Site Design for a Hotel on Pantops, Charlottesville

A Technical Report submitted to the Department of Civil & Environmental Engineering

The Site Design for a Hotel on Pantops, Charlottesville Final Report

NOTES TO BE ADDED

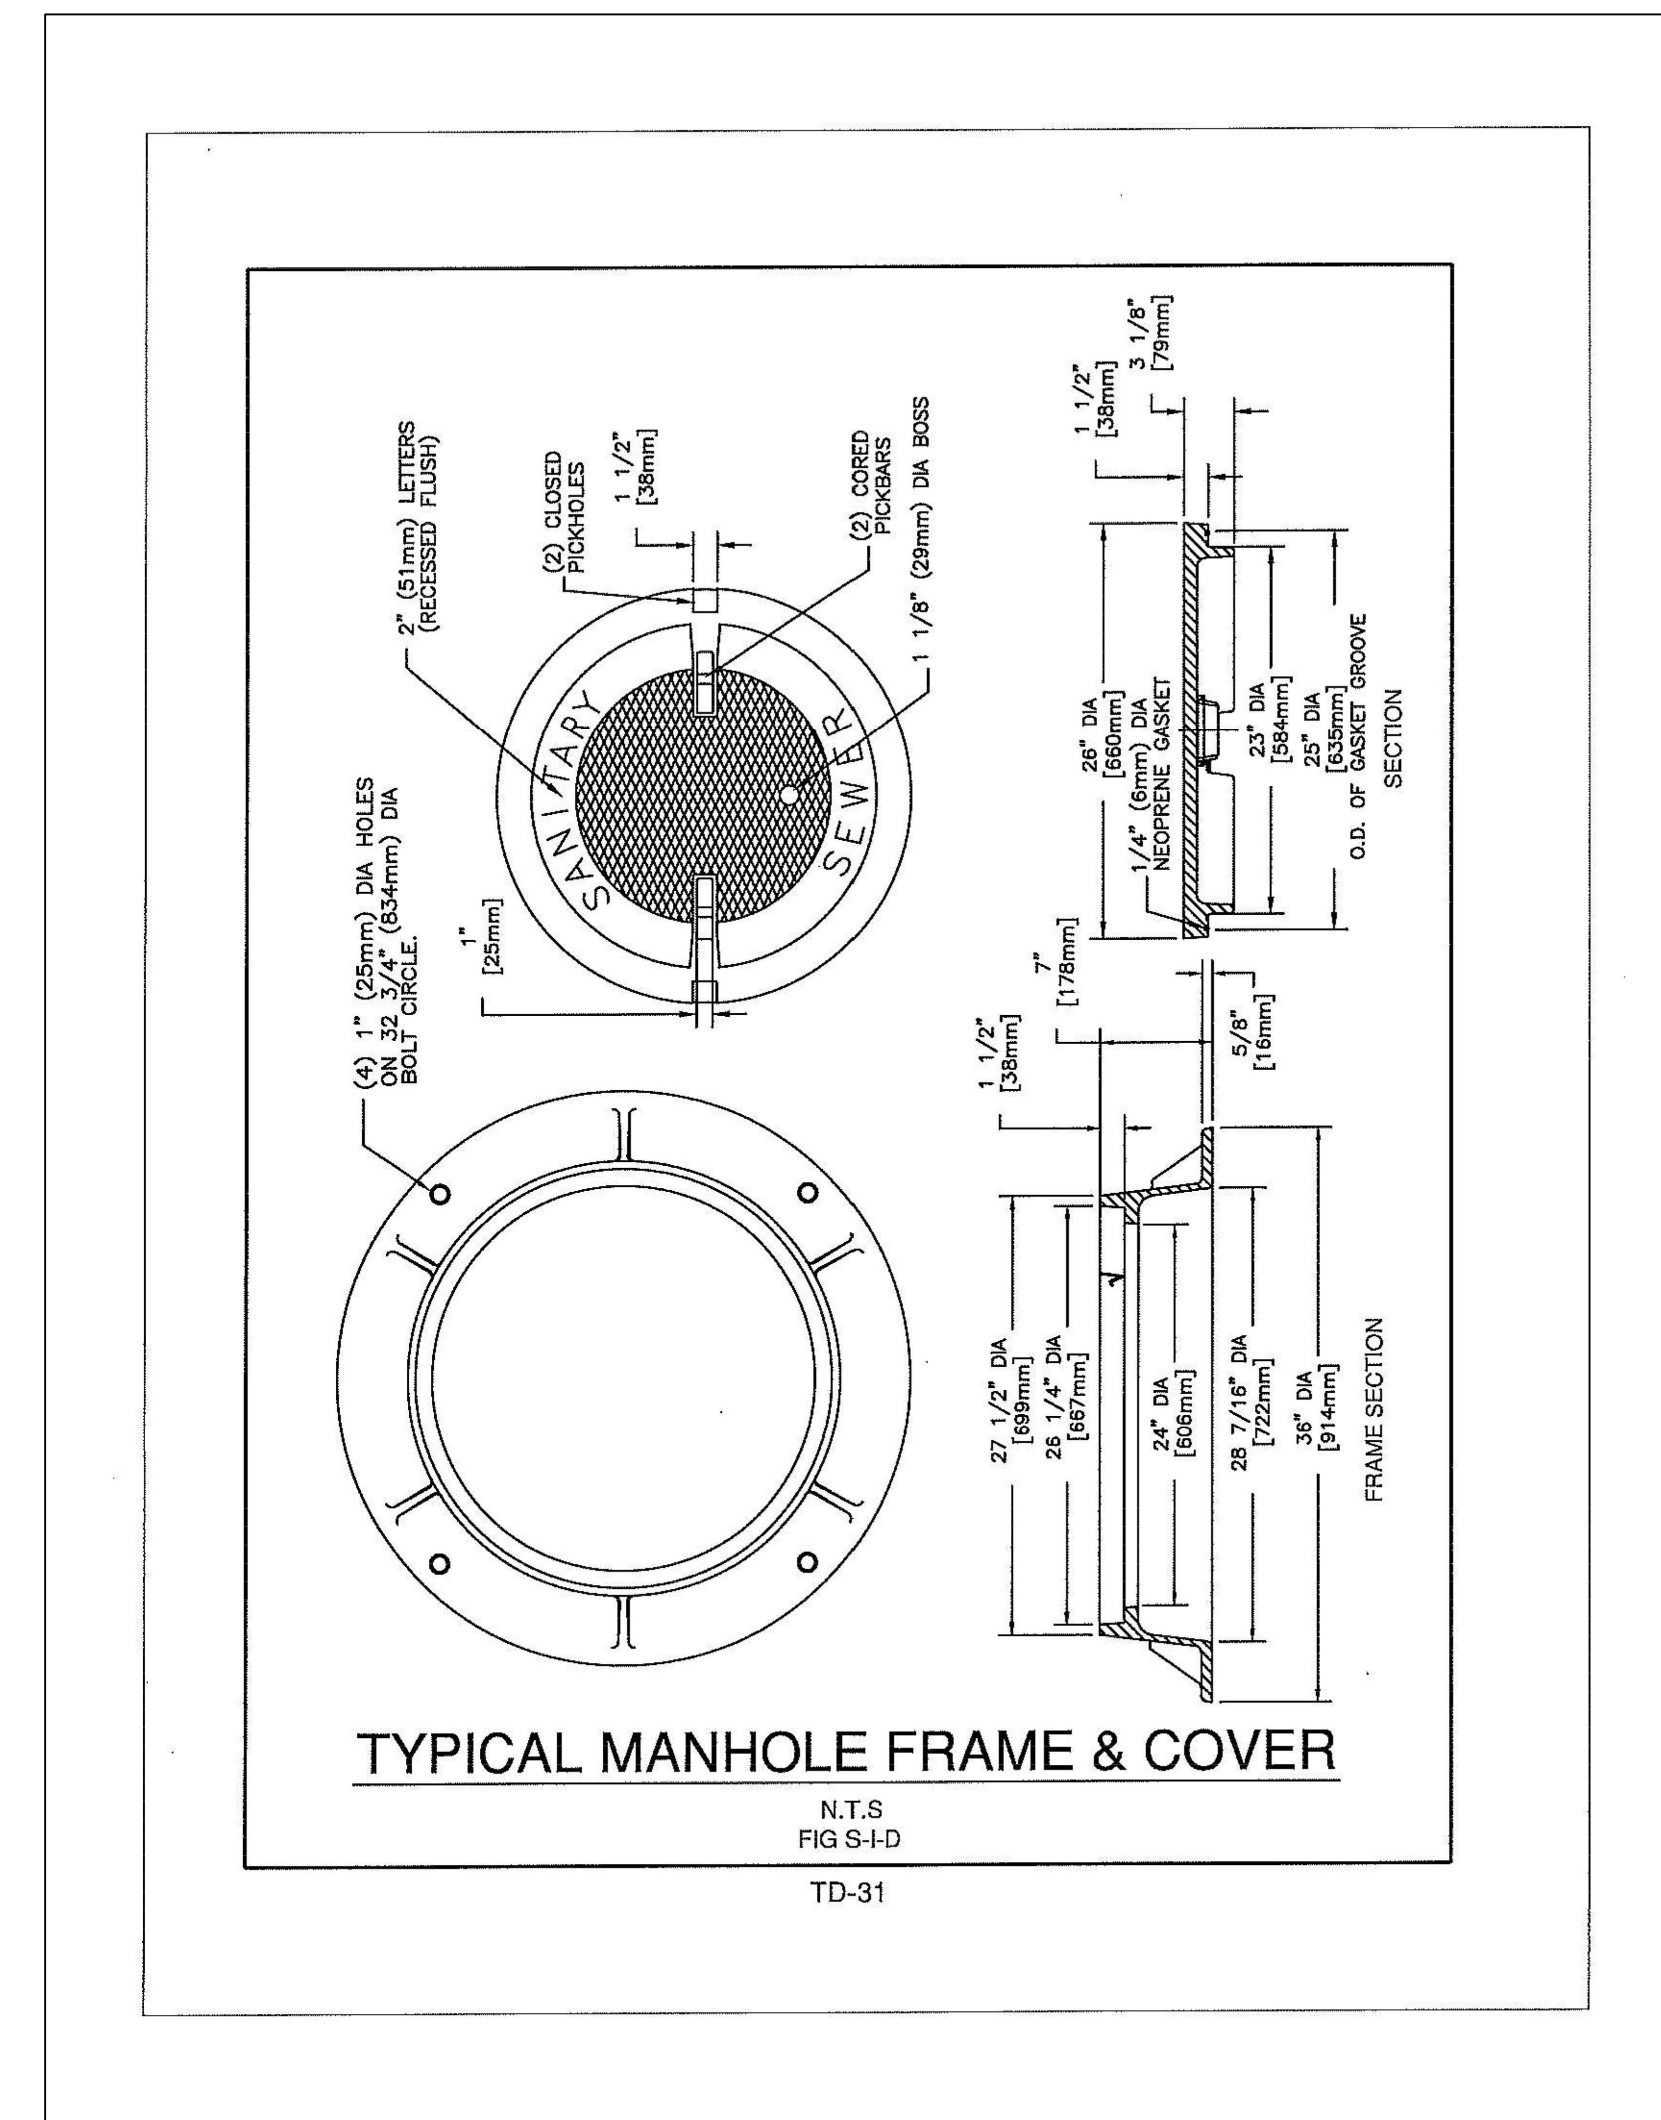
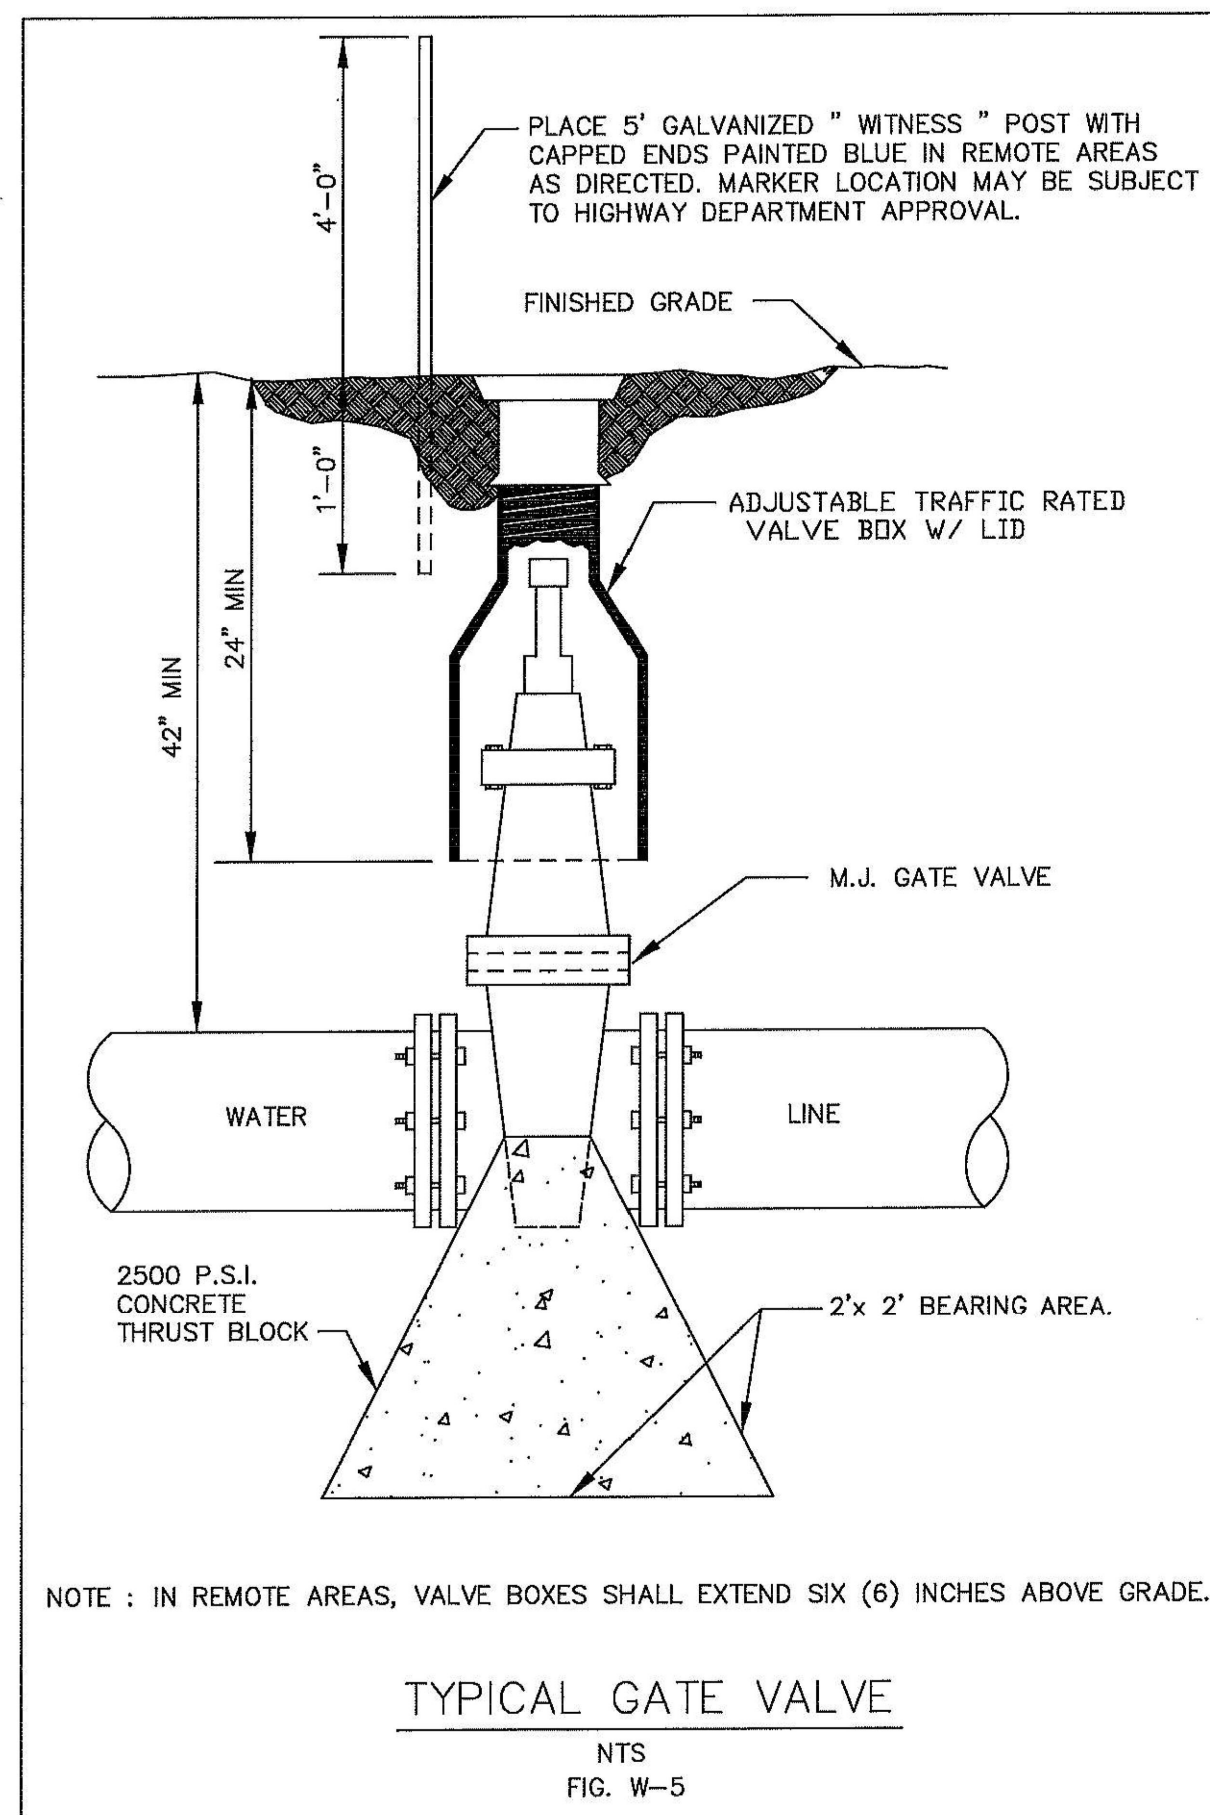
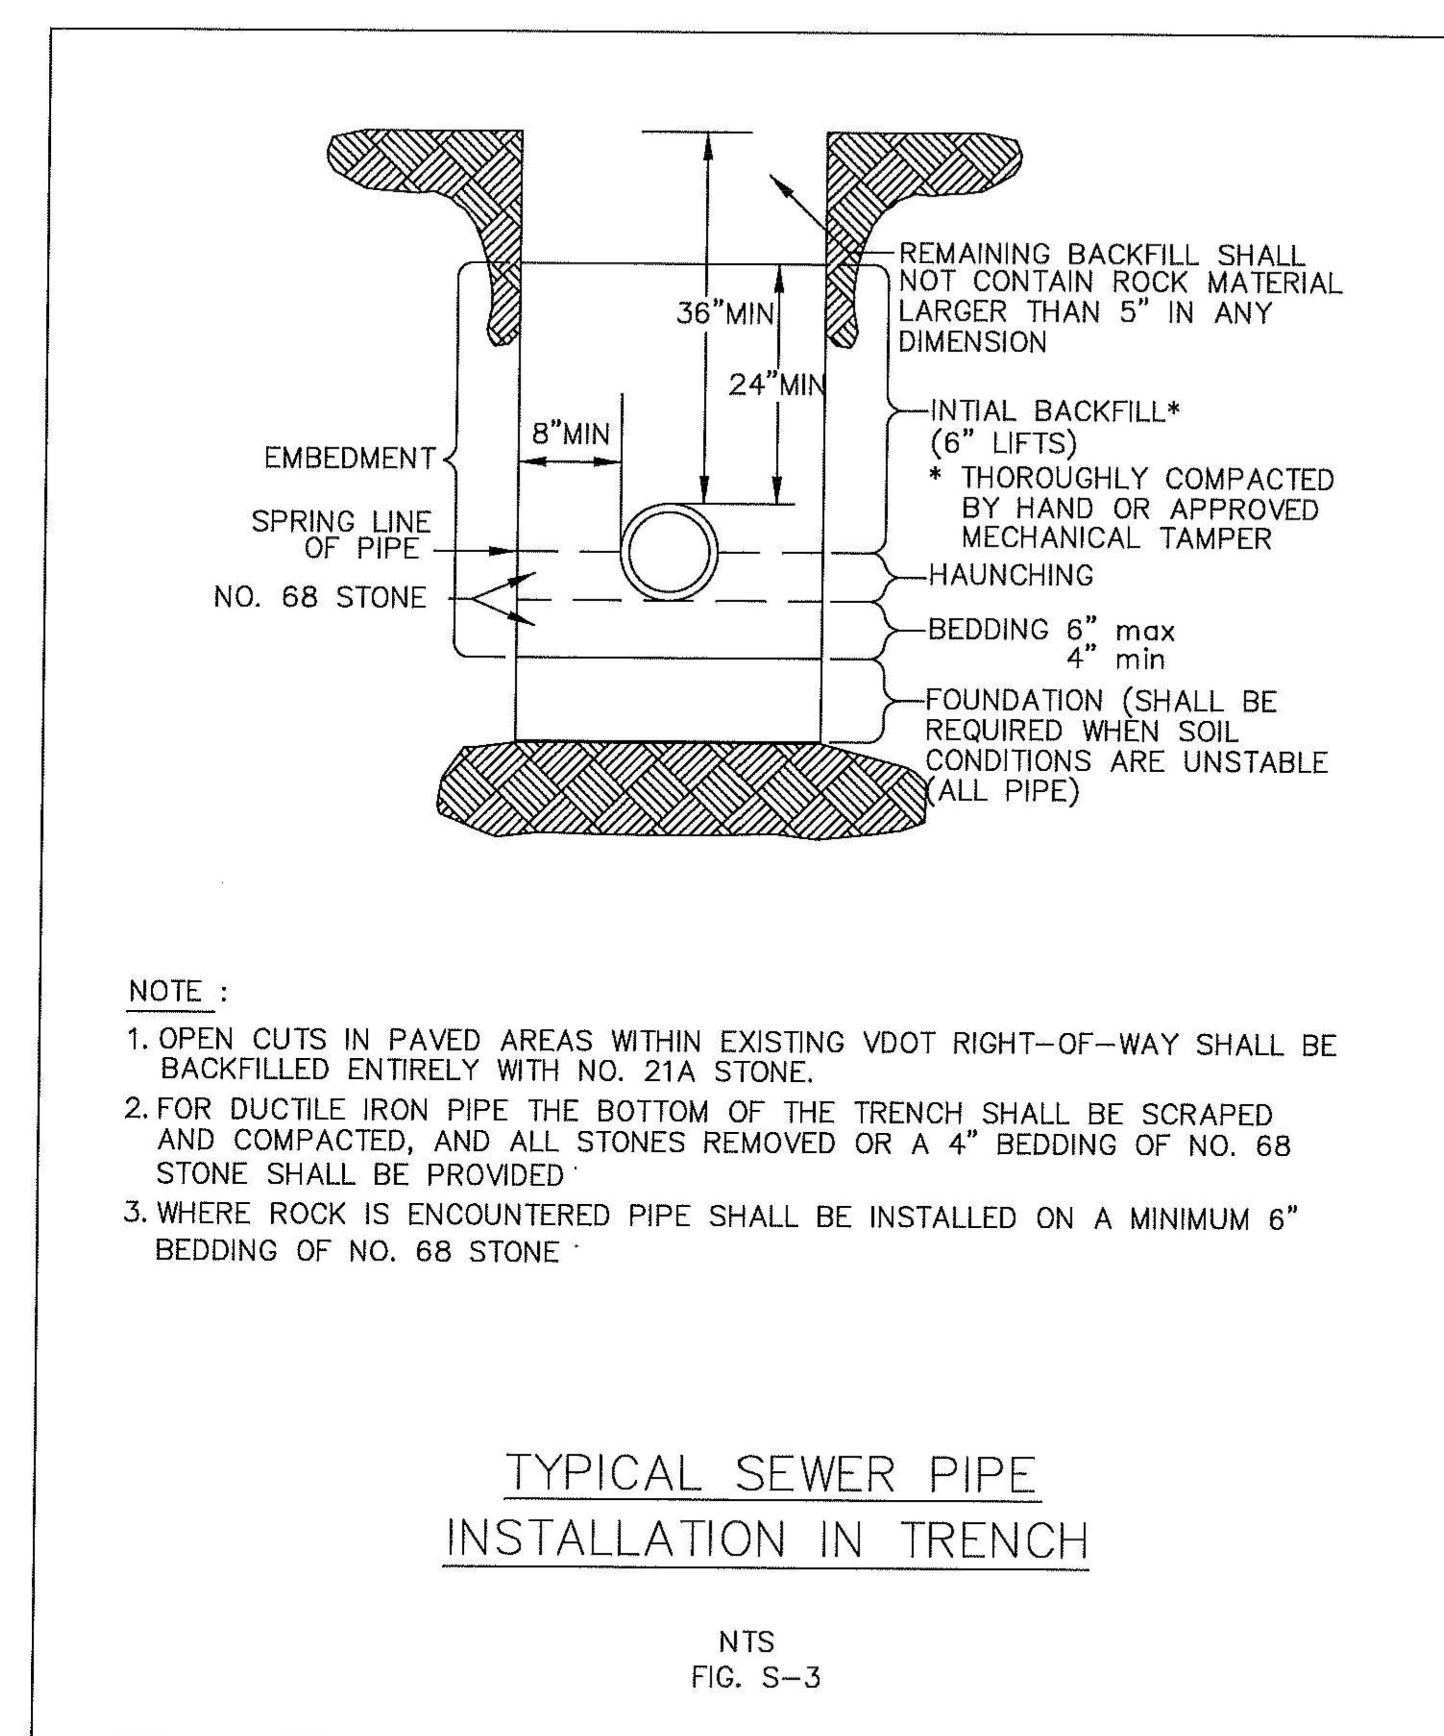
Add ACSA General Water &
Sewer Conditions located
on the Albemarle County
Service Authority website
